Tower Project Name: WVNCC HVAC Controls and Repairs
Tower Project Number: 2020103
Client: WV Community & Technical College System
Prepared By: Tom Valerio
Date: 08/27/2021

Addendum Number: 3

The following drawings are revised as marked and reissued as attached:

DRAWING H7.2 – Weirton Campus Second Floor Plan.

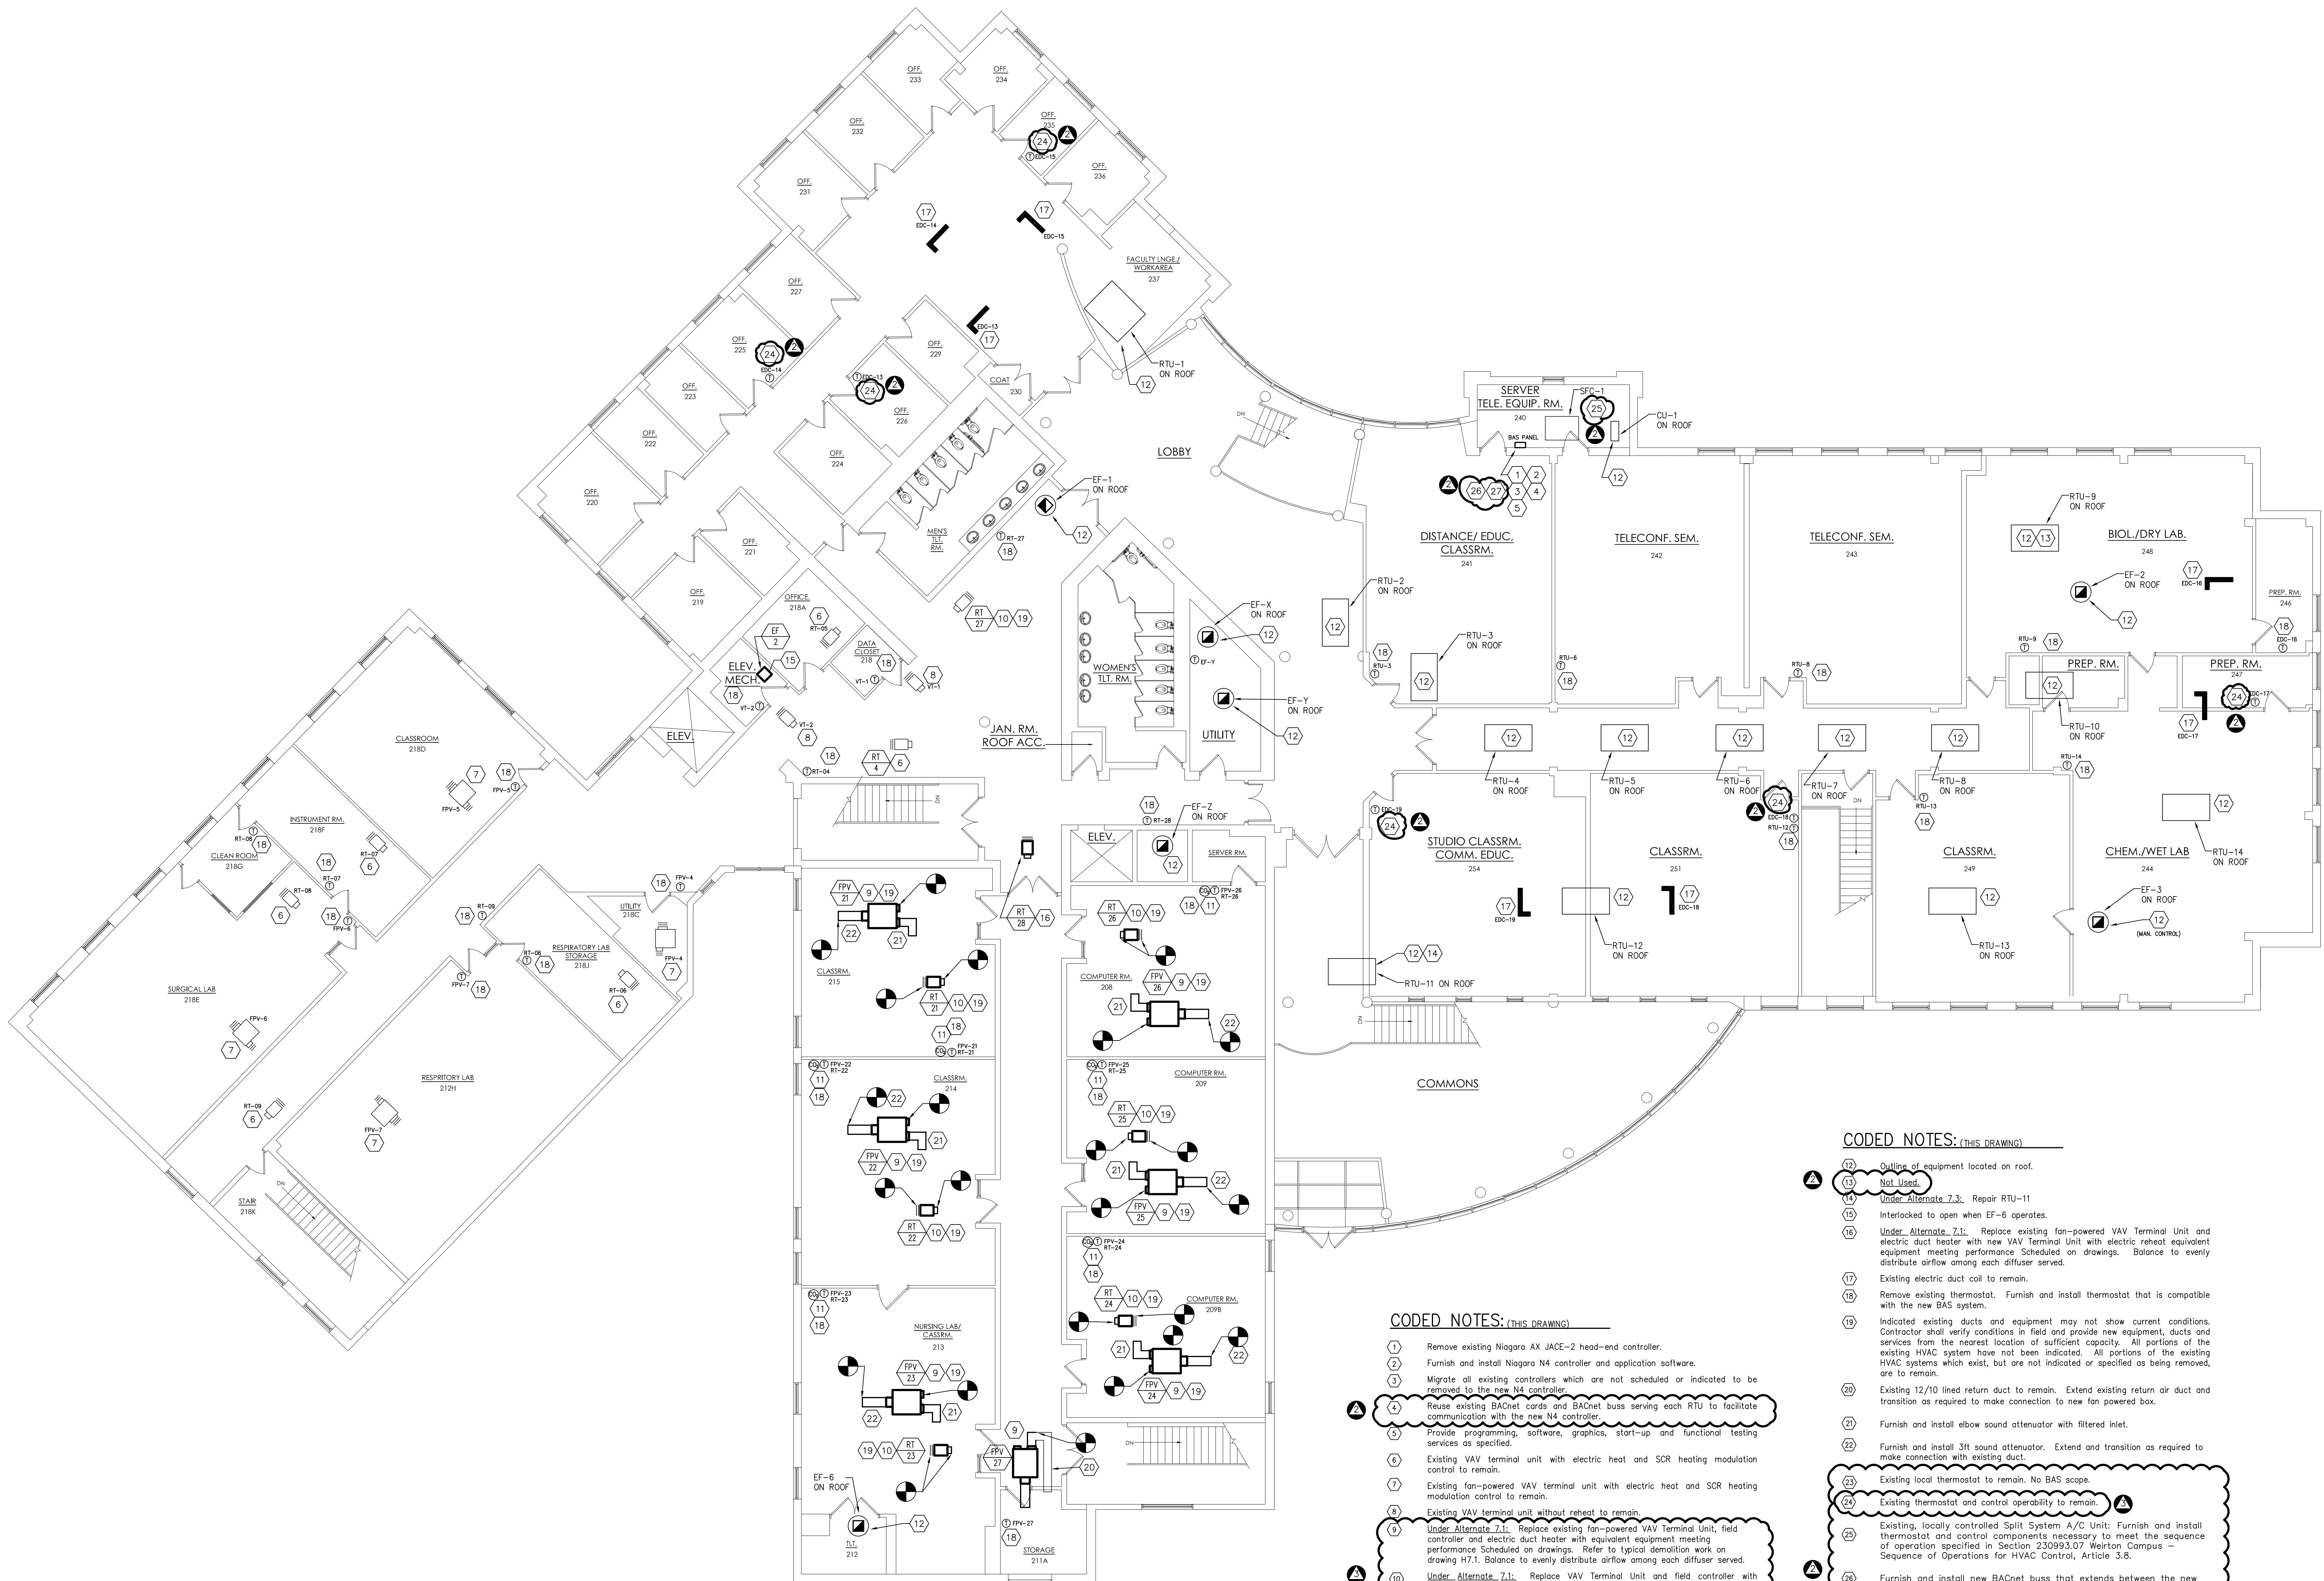
DELETE Coded Note 9 in its entirety and replace with the following:

DELETE Coded Note 10 in its entirety and replace with the following:

DELETE Coded Note 24 in its entirety and replace with the following:

9: Under Alternate 7.1: Replace existing fan-powered VAV Terminal Unit, field controller and electric duct heater with equivalent equipment meeting performance Scheduled on drawings. Balance to evenly distribute airflow among each diffuser served.

10: Under Alternate 7.1: Replace VAV Terminal Unit and field controller with equivalent equipment meeting performance scheduled on drawings. Balance to evenly distribute airflow among each diffuser served.

24: Existing thermostat and control operability to remain.
